This Addendum forms part of the Bid Documents and amends the Bid Documents as described below.

3. ARCHITECTURAL DETAILS - PROJECT MANUAL VOLUME 2

5. **ARCHITECTURAL DRAWINGS**

1 GROUND FLOOR - FIRE ALARM AND SECURITY LAYOUT
E10 SCALE: 1/100

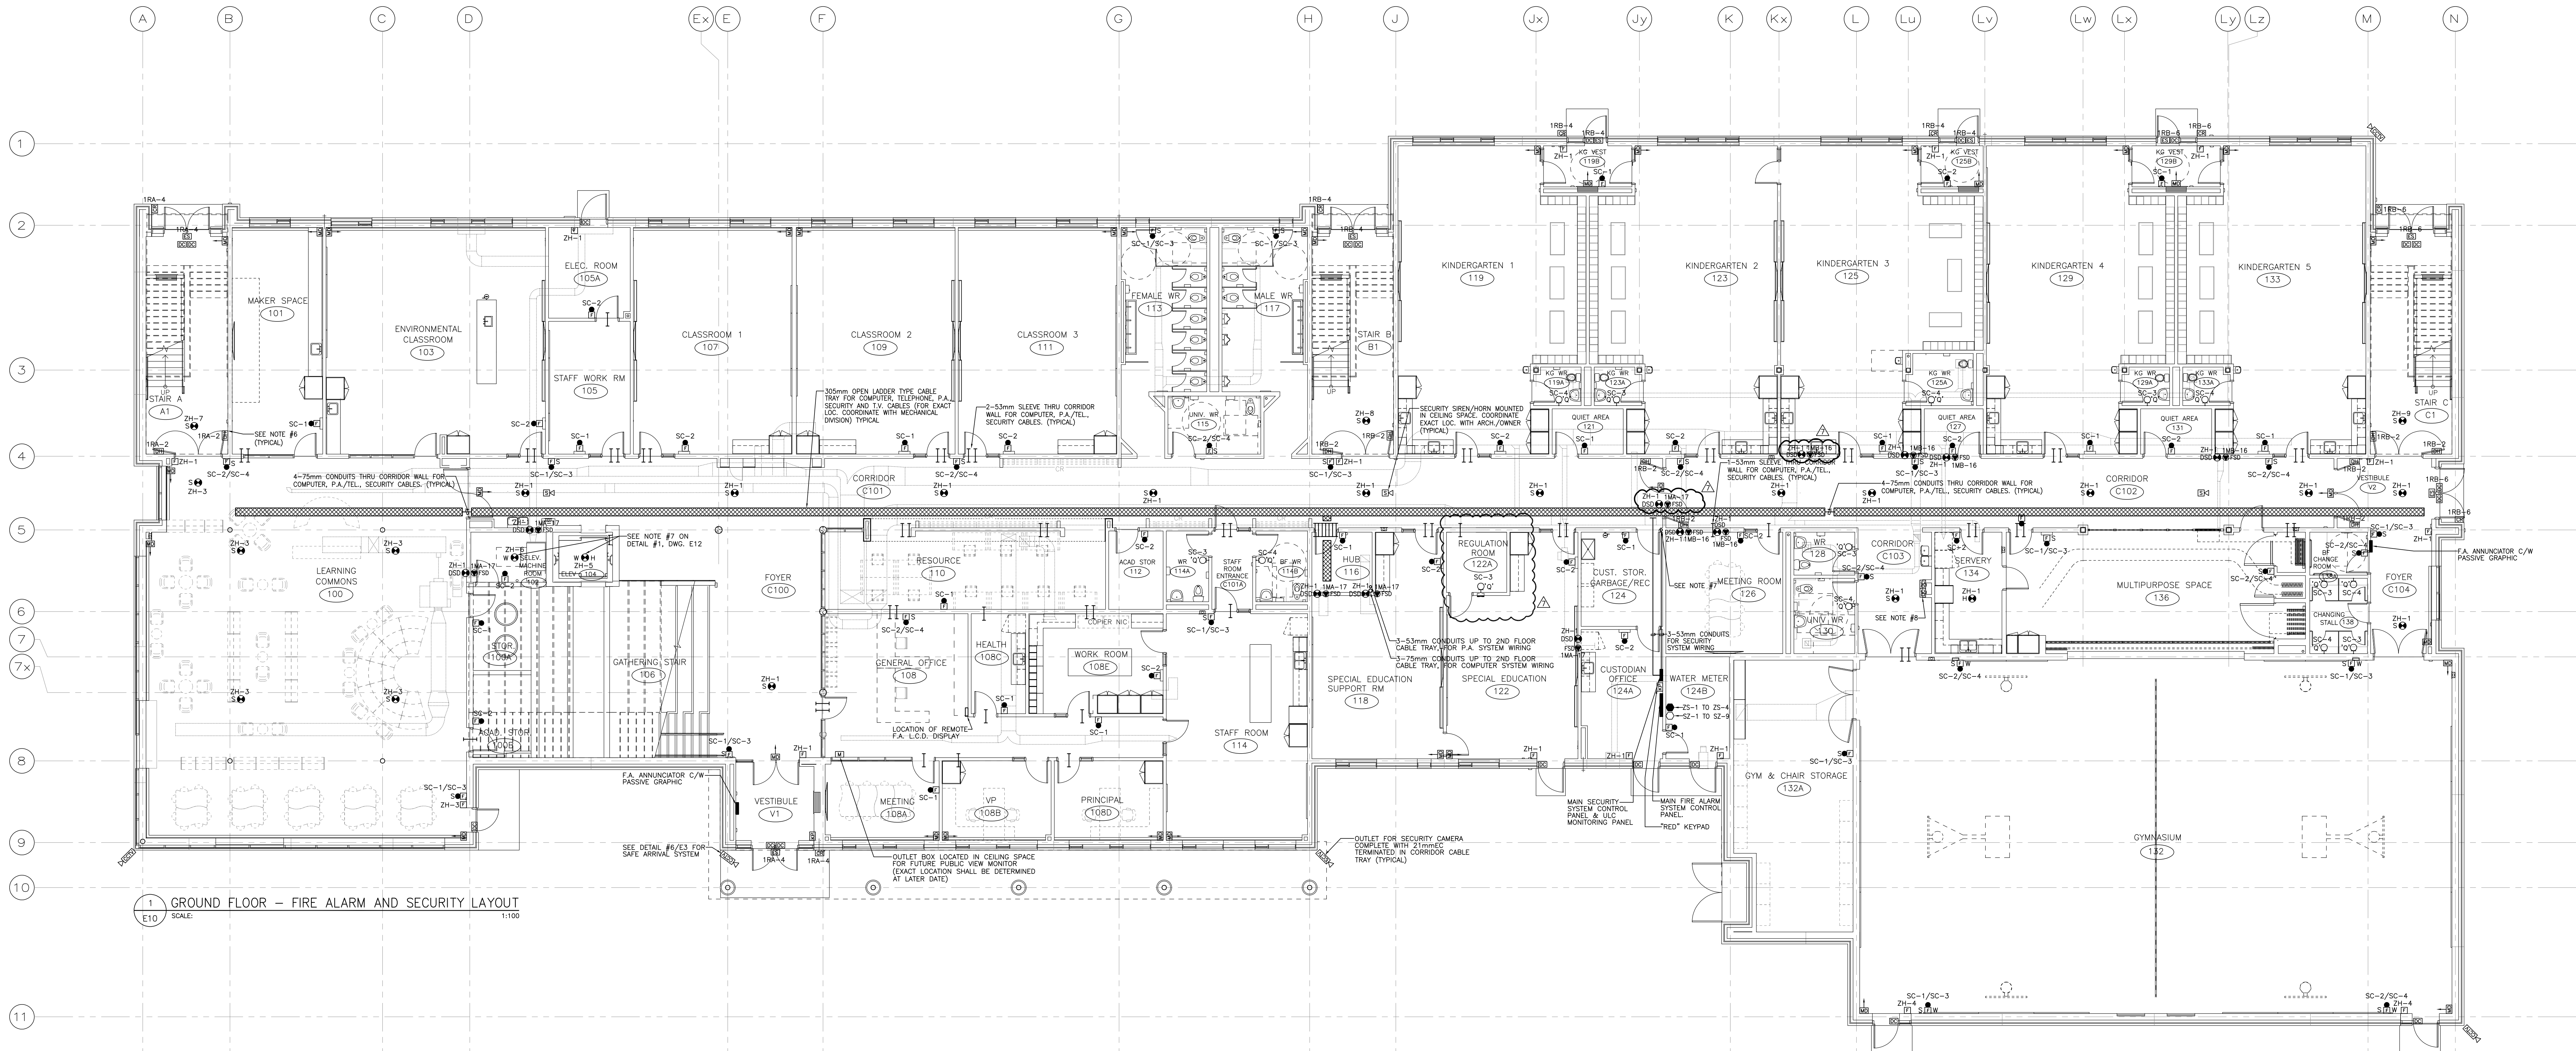
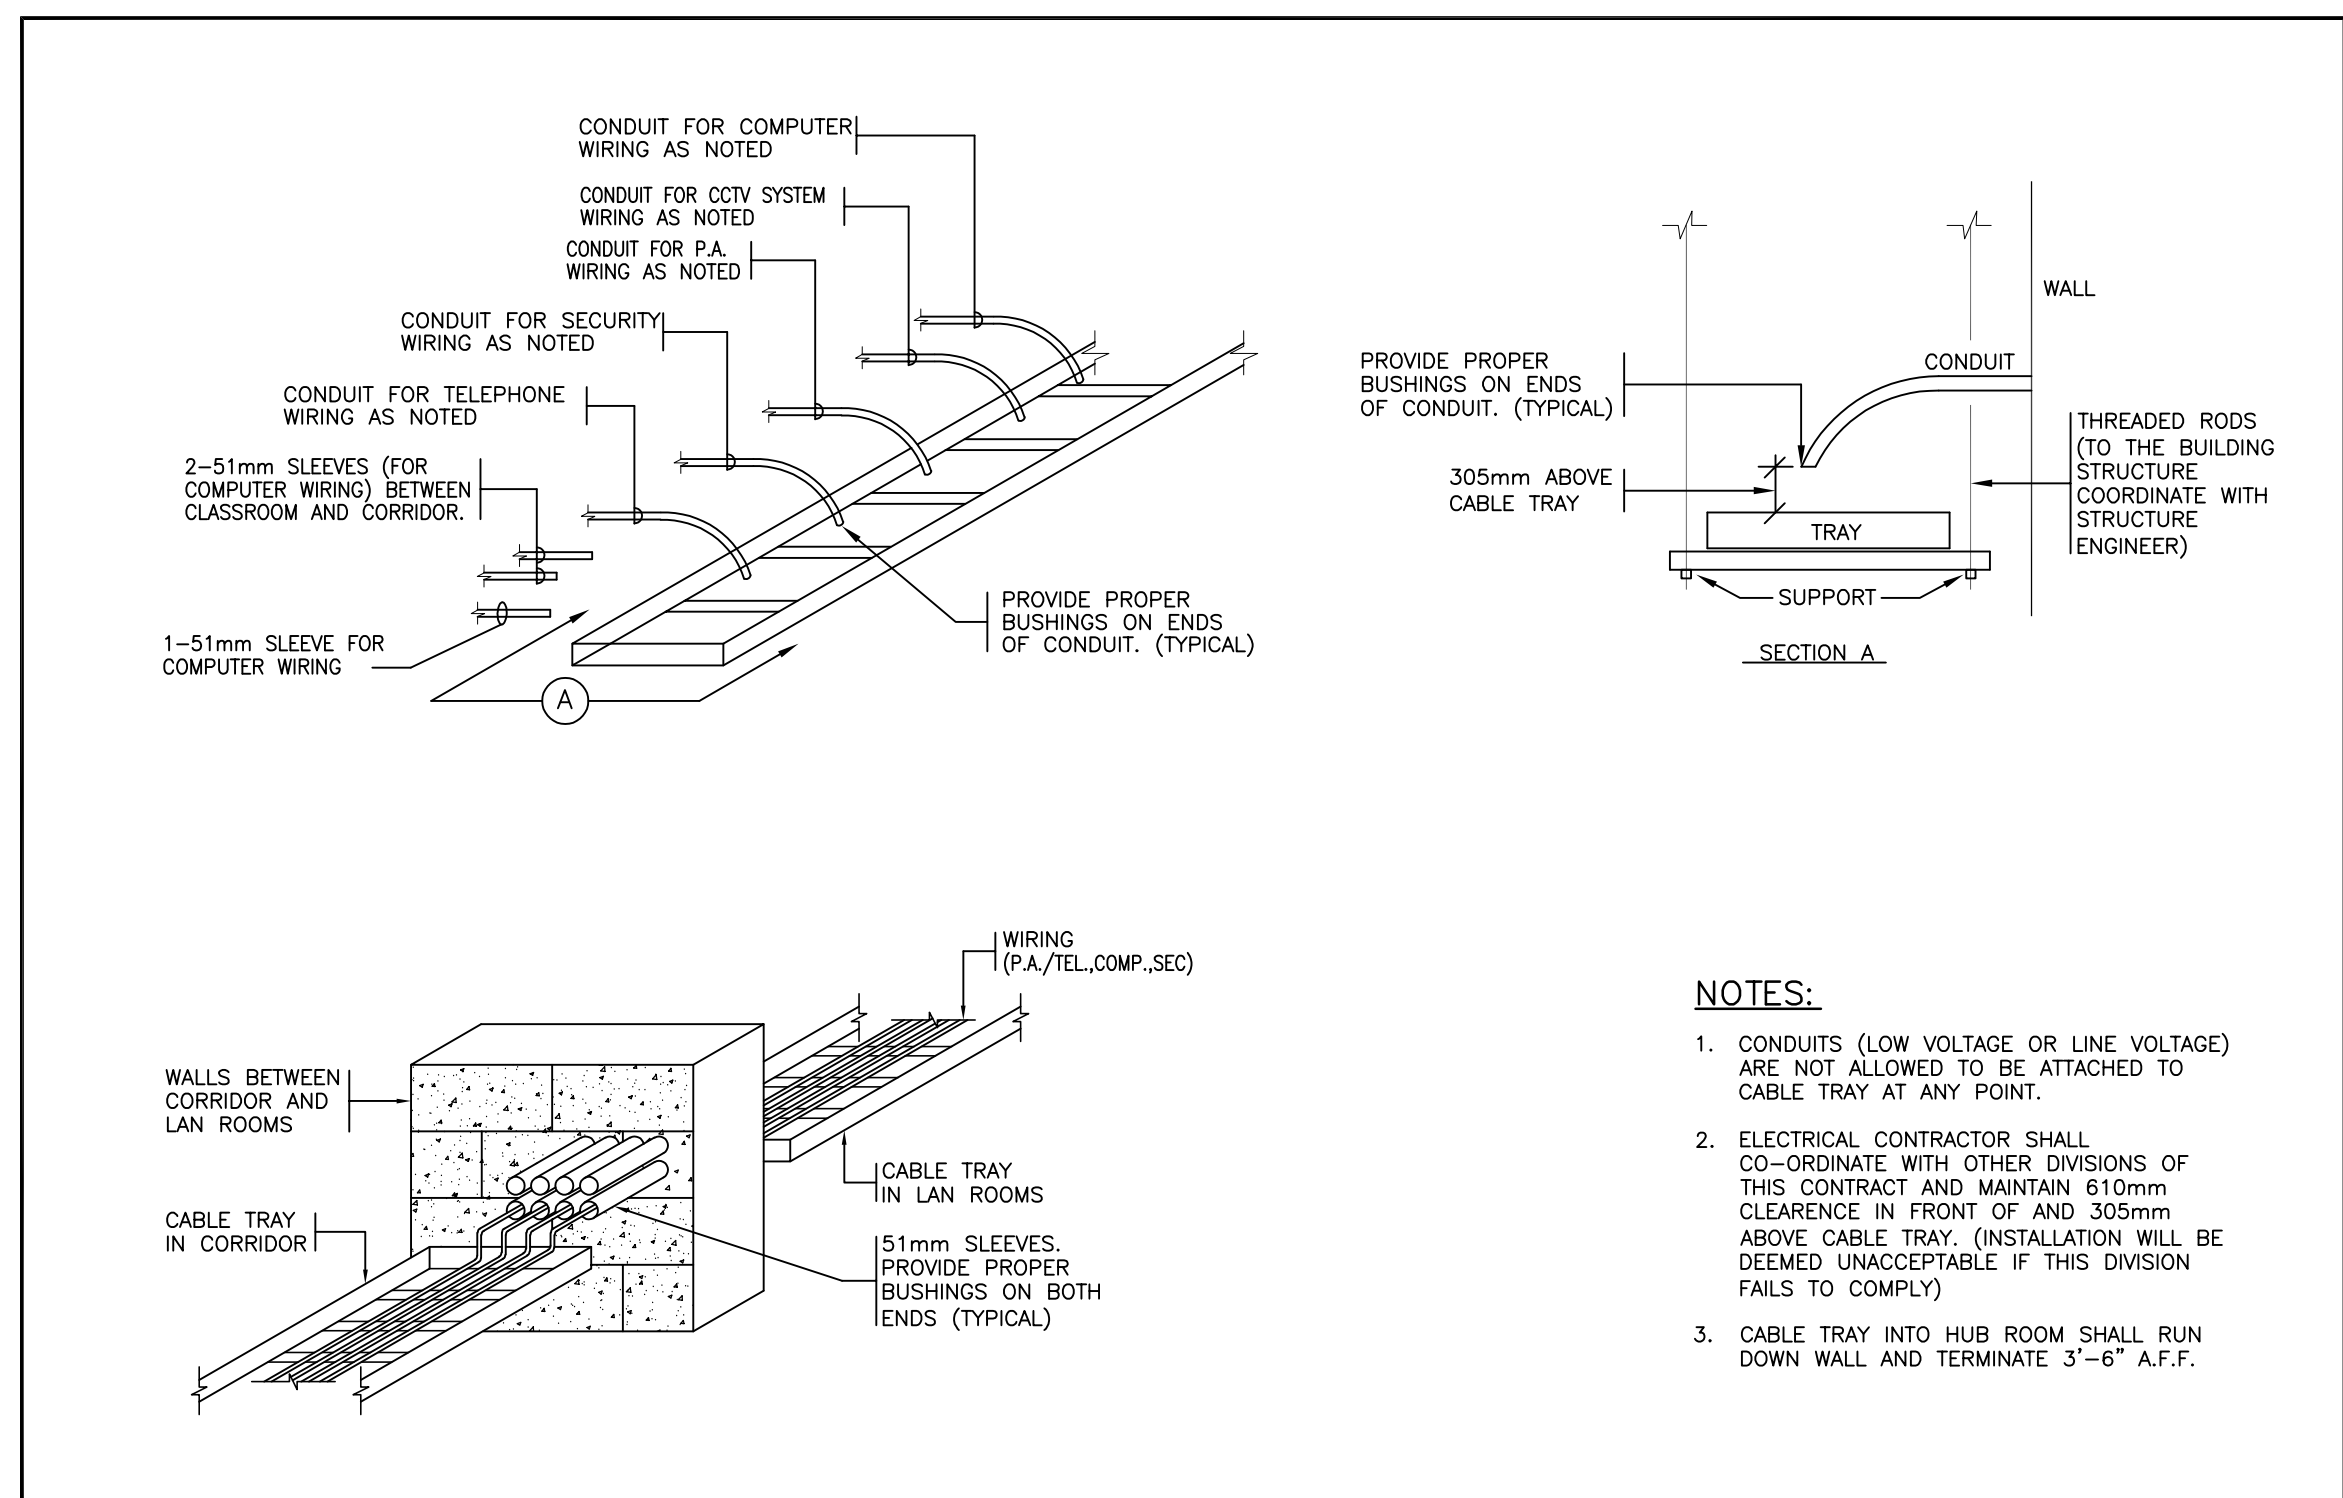
1. In Corridor C102 added Combination Fire/Smoke damper and revised the cct#’s. Refer to drawing.
